REF NO.	AT01011
DATE	Feb. 16, 2001
•	Page 1 of 14

SUBJECT: REPAIR OF HYDRAULIC PIPING FLANGE PORTION CRACK ON

WA1200-3

PURPOSE: To introduce modification procedures to prevent occurrence of cracks in

1.2 Installing the hydraulic tubes

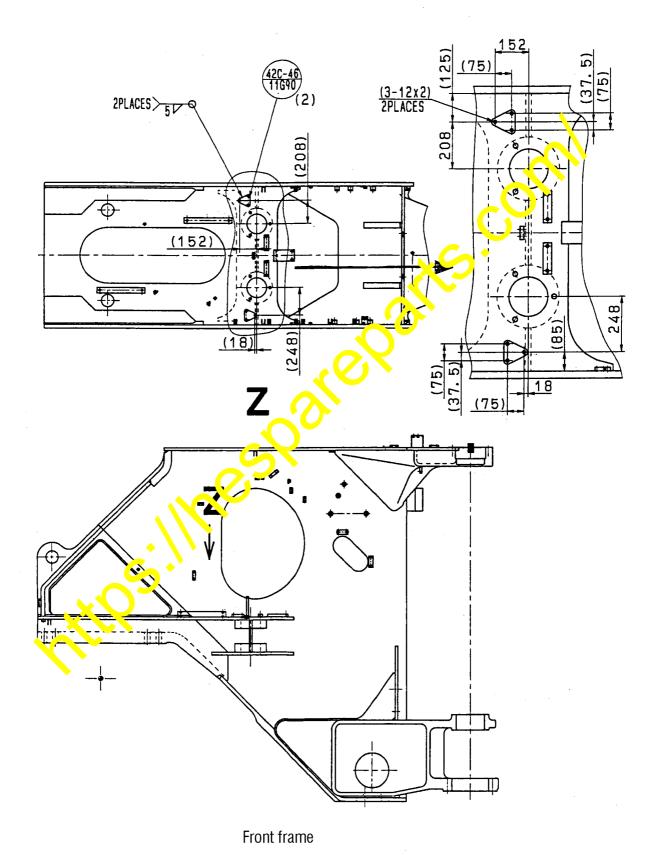
- 4. Modification procedures
- 4.1. Modifying the pipings connecting between the work equipment valve and the boom cylinders located inside the front frame
 - 1.1 Removing the hydraulic tubes
 Remove the five hydraulic tubes marked "×". (Discard the removed tubes.)
 The tube mounting bolts (01010-81250) and washers (01643-31232) are being reused.

Install the five newly prepared tubes marked \Rightarrow .

Tightening torque: 98 - 123 Nm (10 - 12.5 kgm)

All the mounting bolts are to carry the part no. 01010-81250.

Note: Replace the O-rings with new parts.

1.3 Supplementing the seats to the front frame

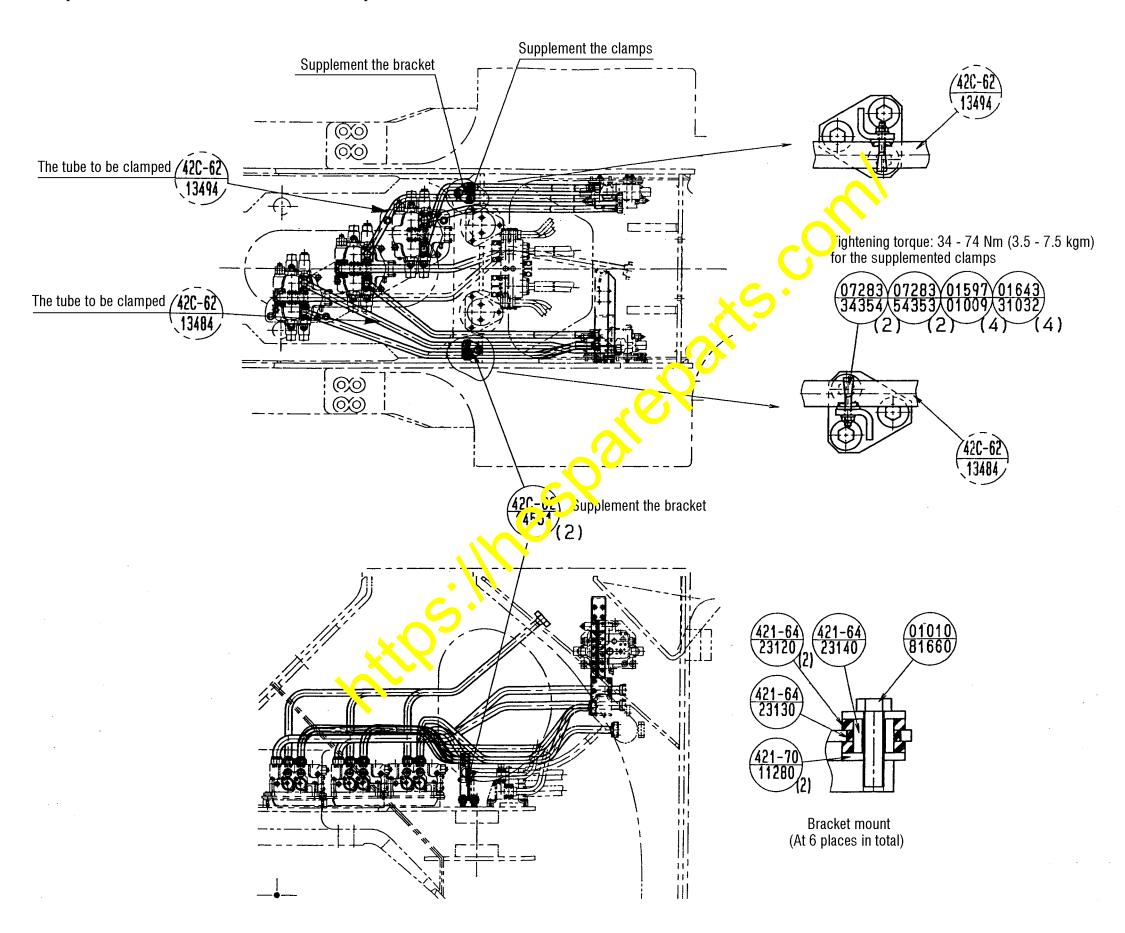
Weld the two seats (42C-46-11G90) to the positions designated in the drawing indicated below.

(Apply corrective painting to the welded surfaces.)

2.2 Supplementing the vibration preventive brackets

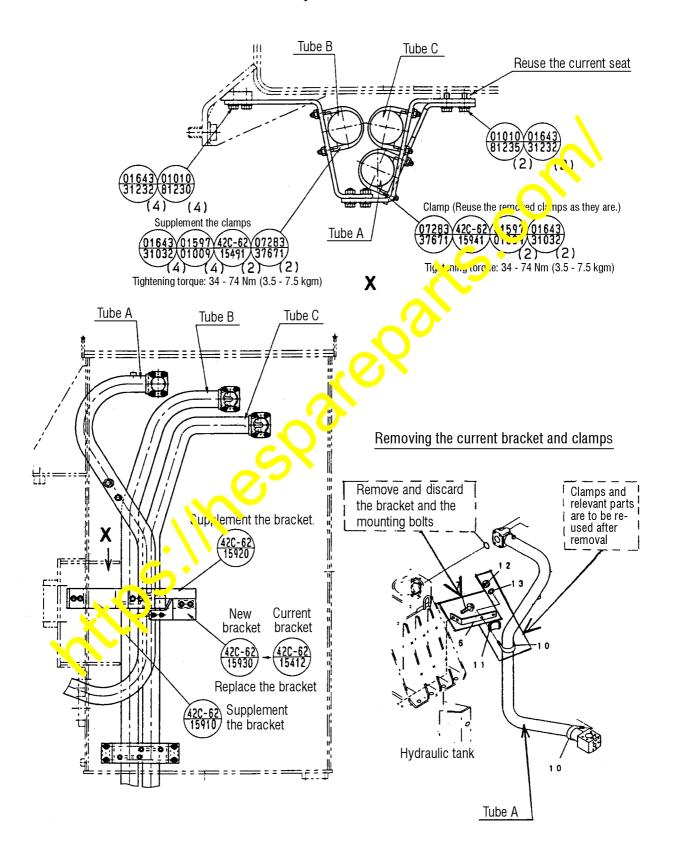
Remove the current bracket and clamps clamping the tube "A". (The clamp is being reused.)

Install the new brackets and clamp the tubes A thru C.
